FED. ROAD DIST. NO.	STATE	PROJ. NO.	FISCAL YEAR	SHEET NO.	TOTAL SHEETS
HAWAII	HAW.	83D-01-96M	1996	C.O.29	50

△ TYPE "B" UPGRADE

(AT SOUTH KAHANA, NORTH KAHANA, AND SOUTH PUNALUU BRIDGES)

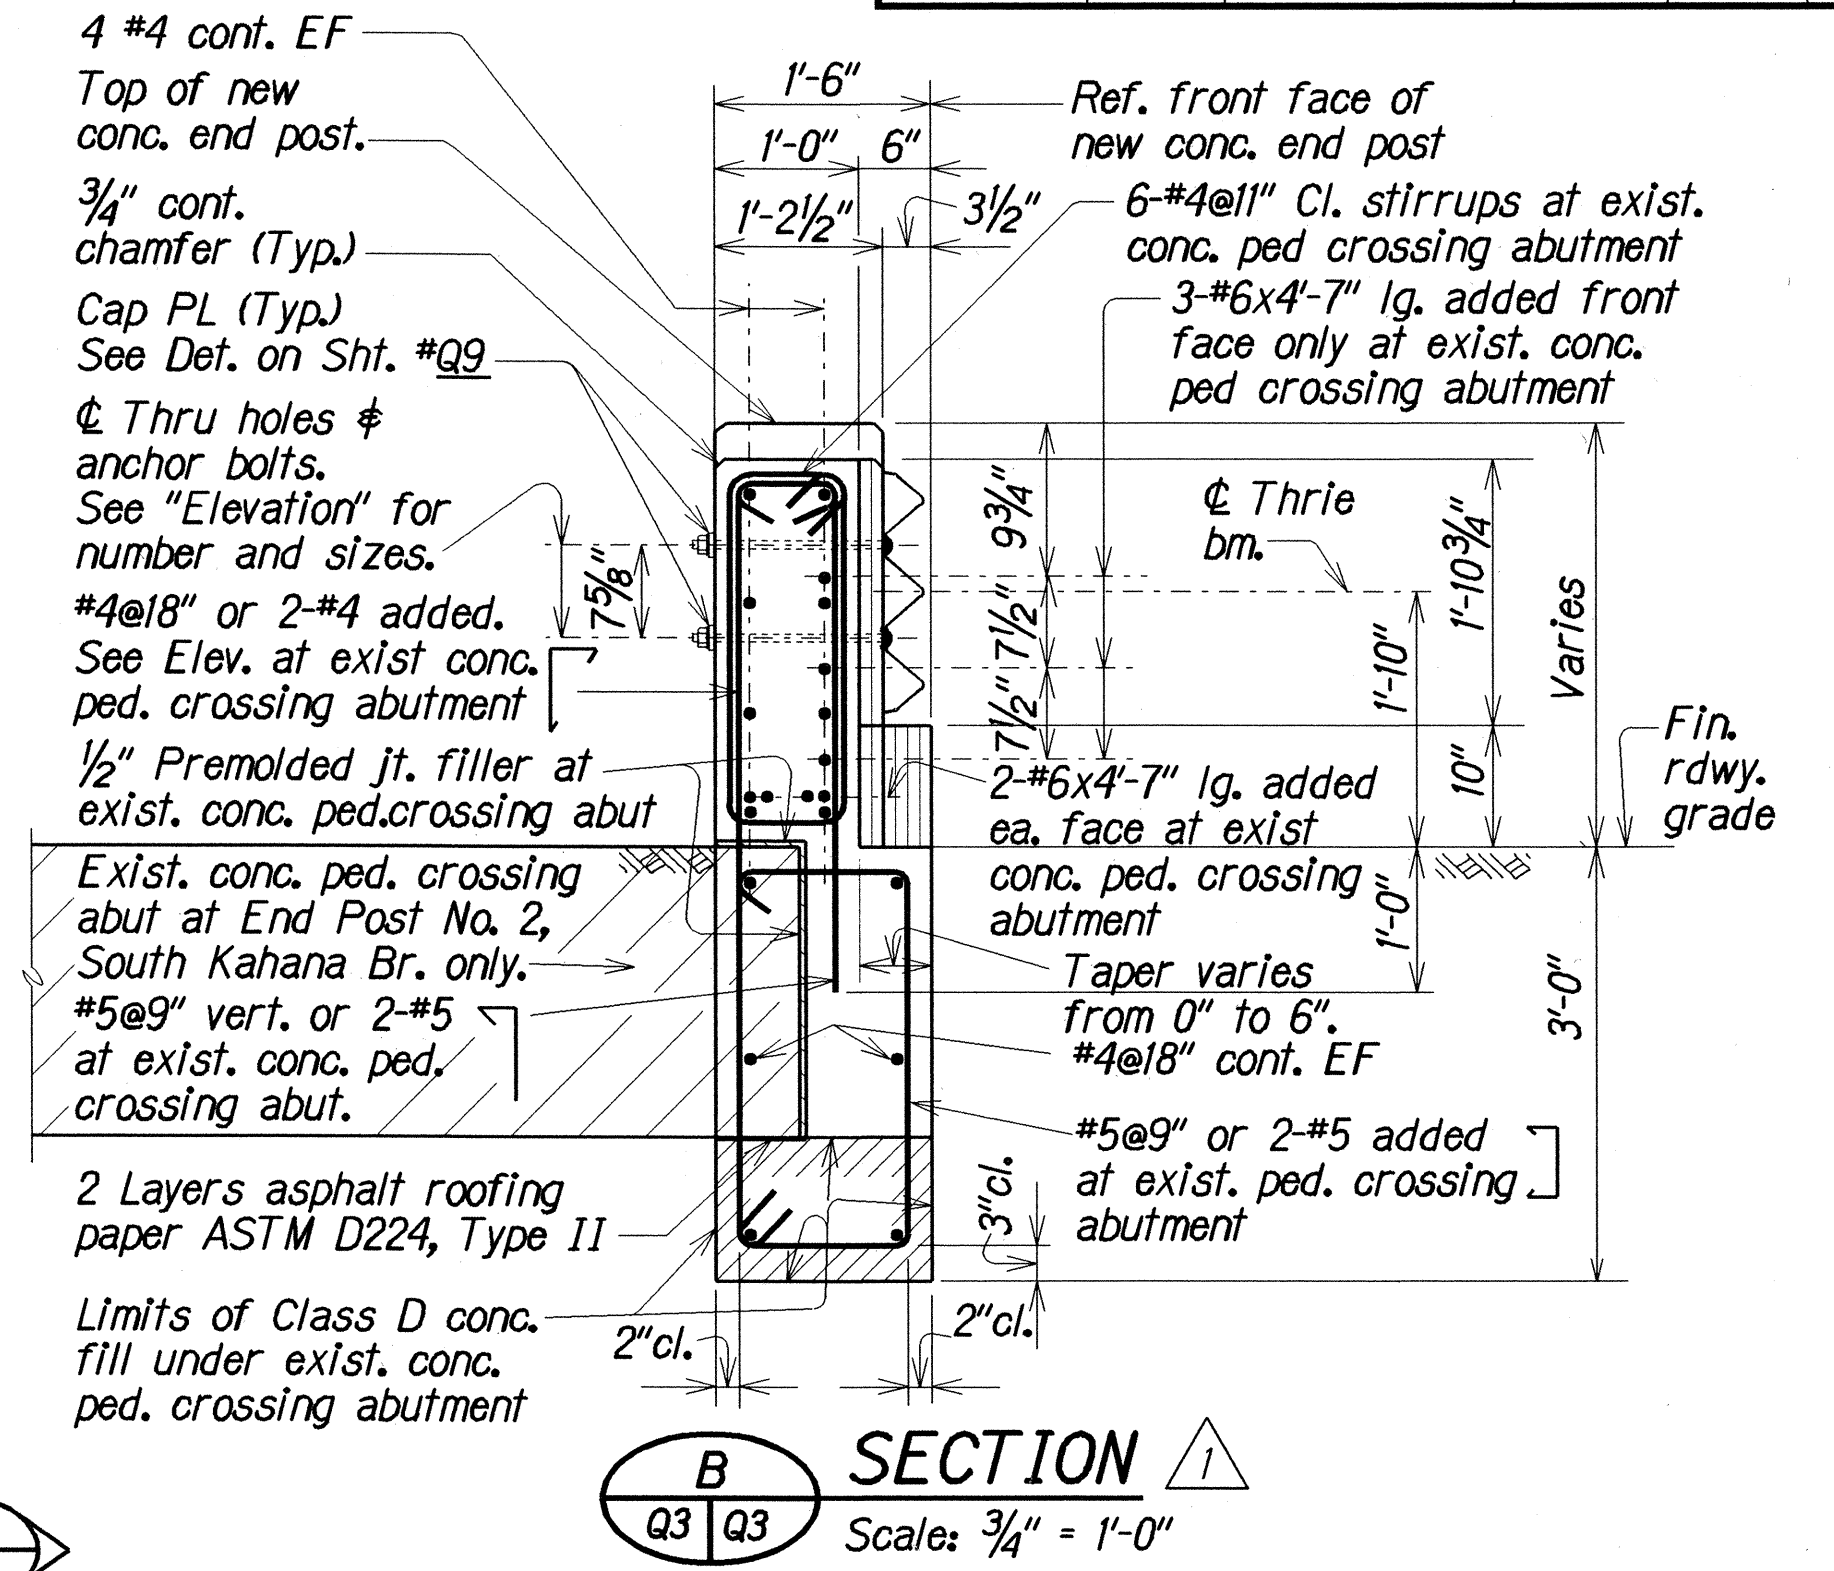
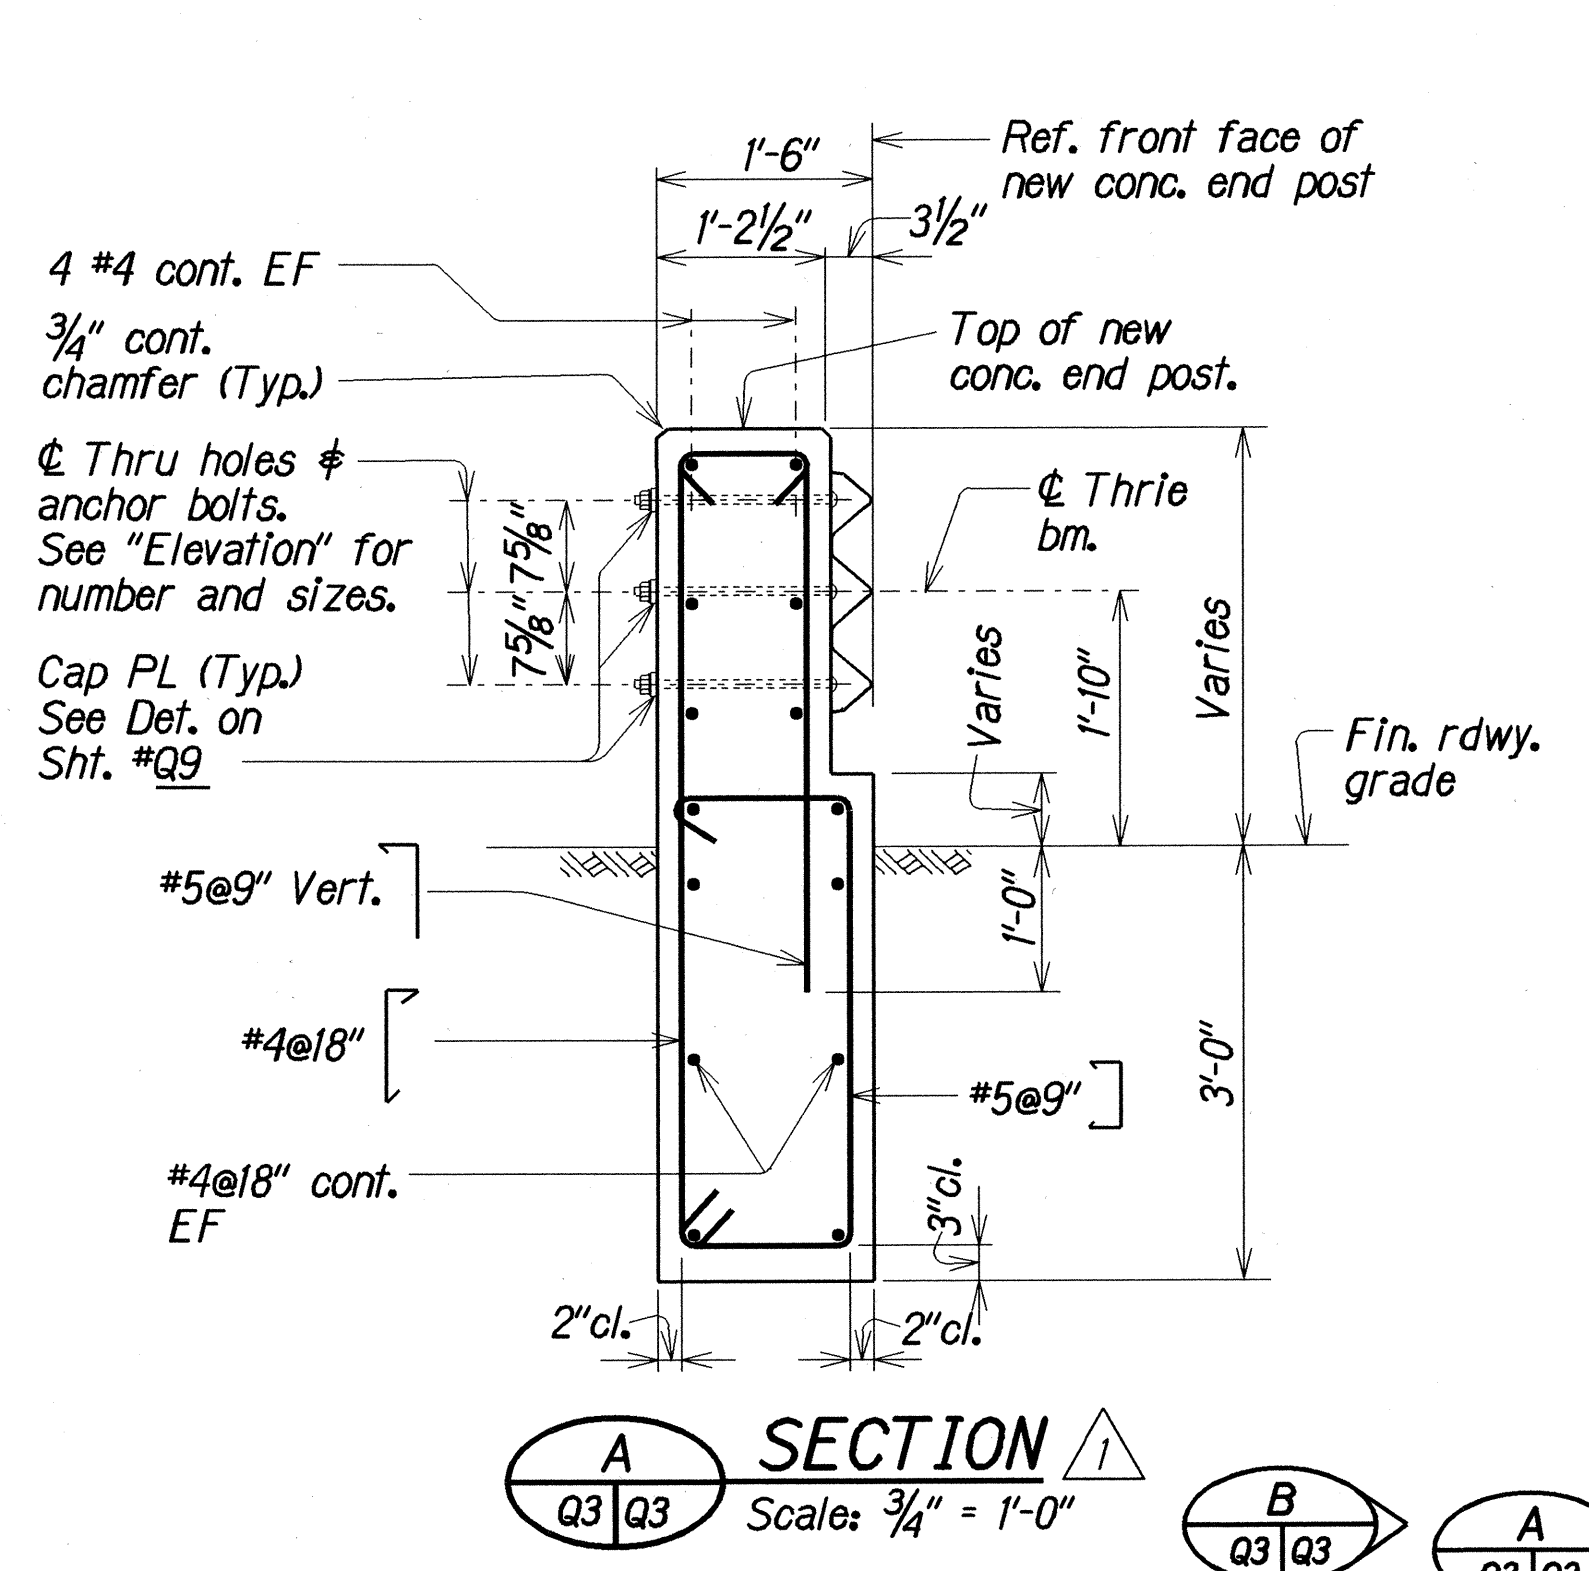
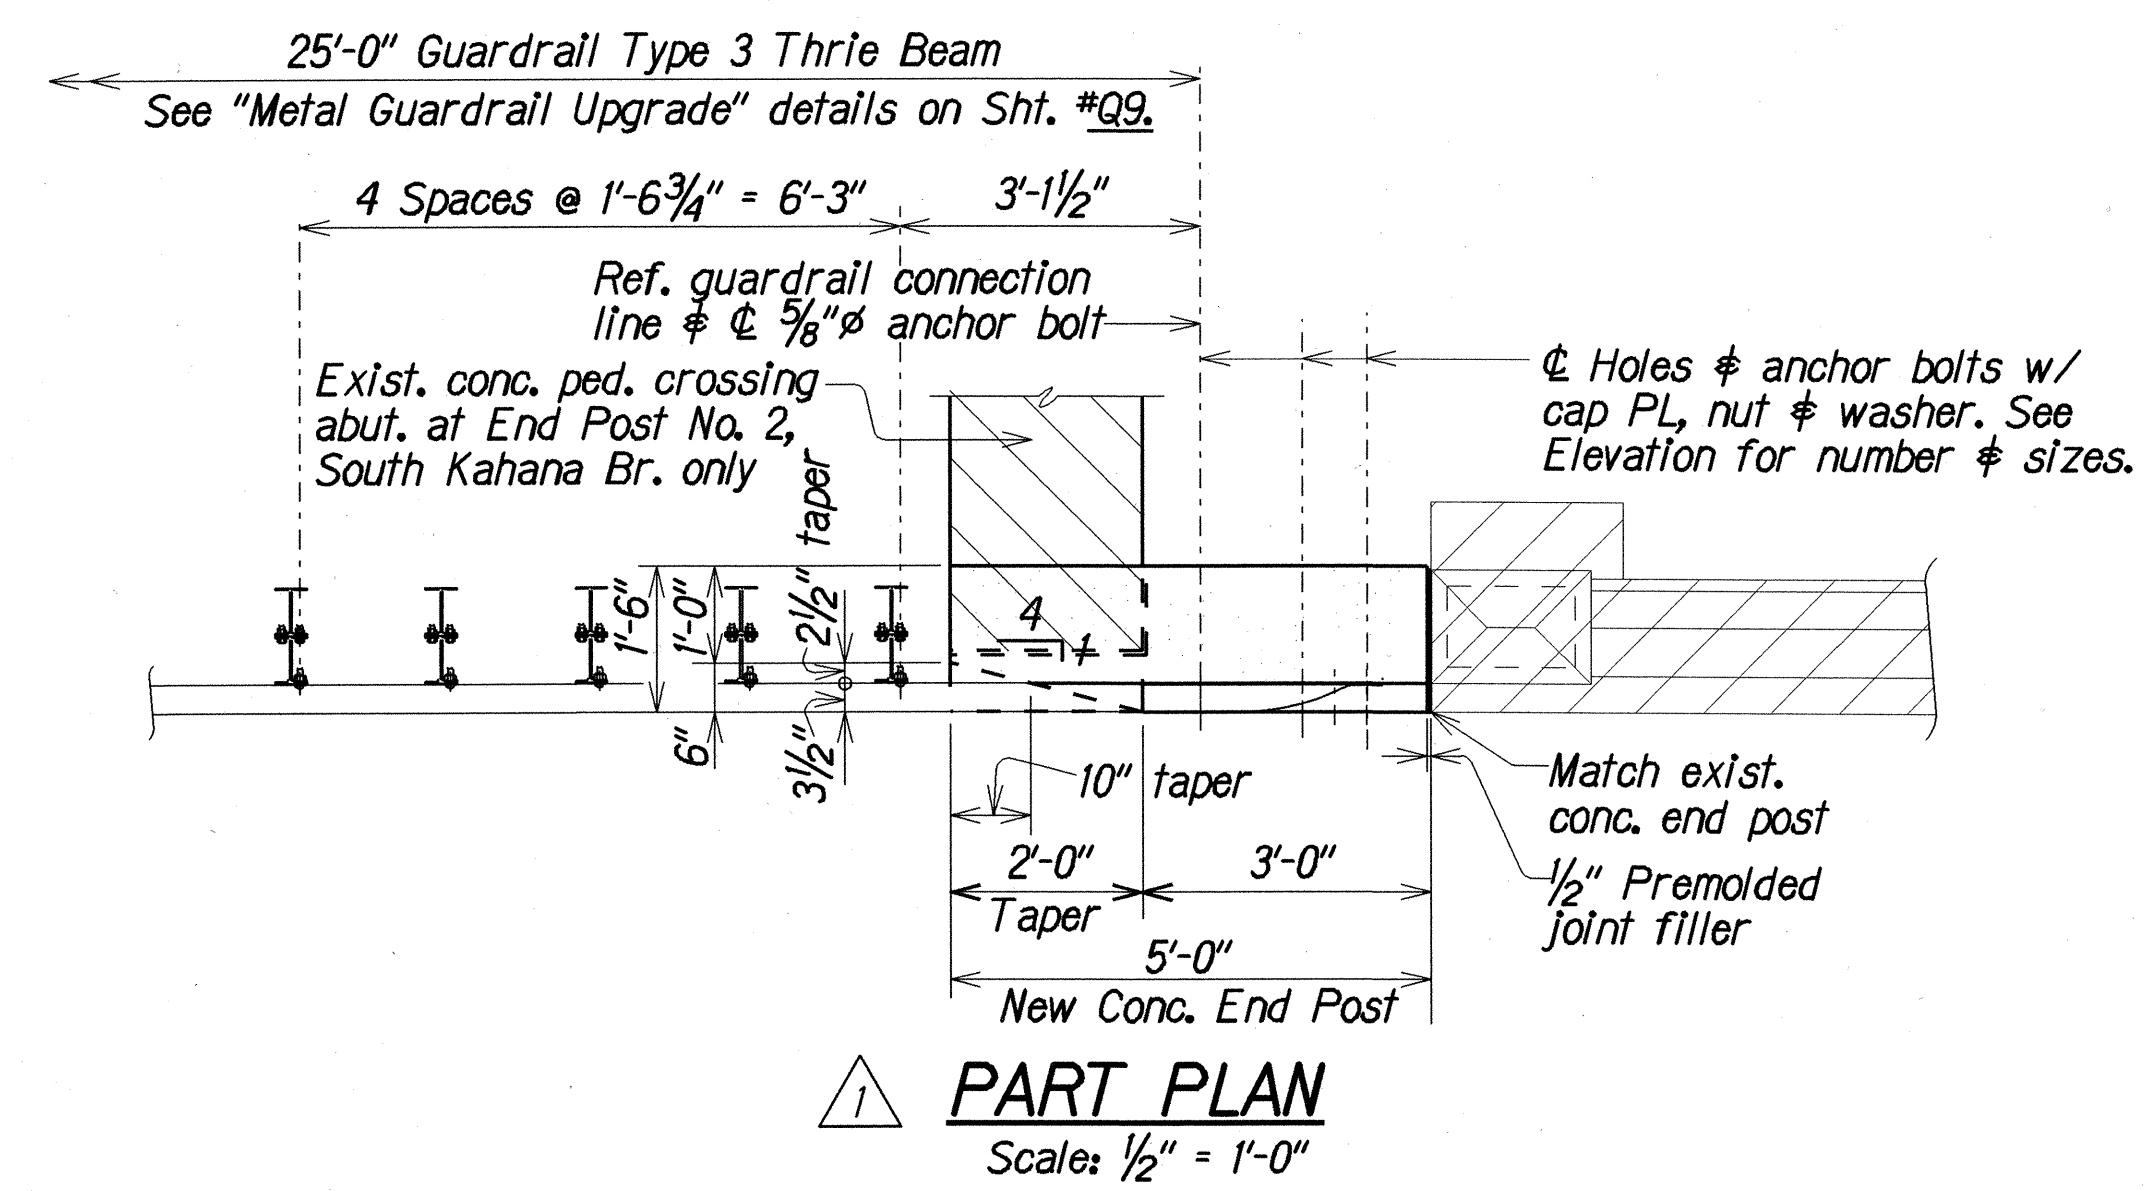
Added detail and information to accommodate exist. conc. ped. crossing abut. at End Post No. 2, South Kahana Bridge. Dimensions, labels and details were moved to make space for additions.	2/11/97
DATE	REVISIONS
STATE OF HAWAII DEPARTMENT OF TRANSPORTATION HIGHWAYS DIVISION SOUTH KAHANA, NORTH KAHANA, AND SOUTH PUNALUU BRIDGES TYPE "B" UPGRADE - END POST CONNECTION KAMEHAMEHA HIGHWAY RESURFACING Crouching Lion to Puhuli Street Project No. 83D-01-96M Scale: As Noted Date: May 1996
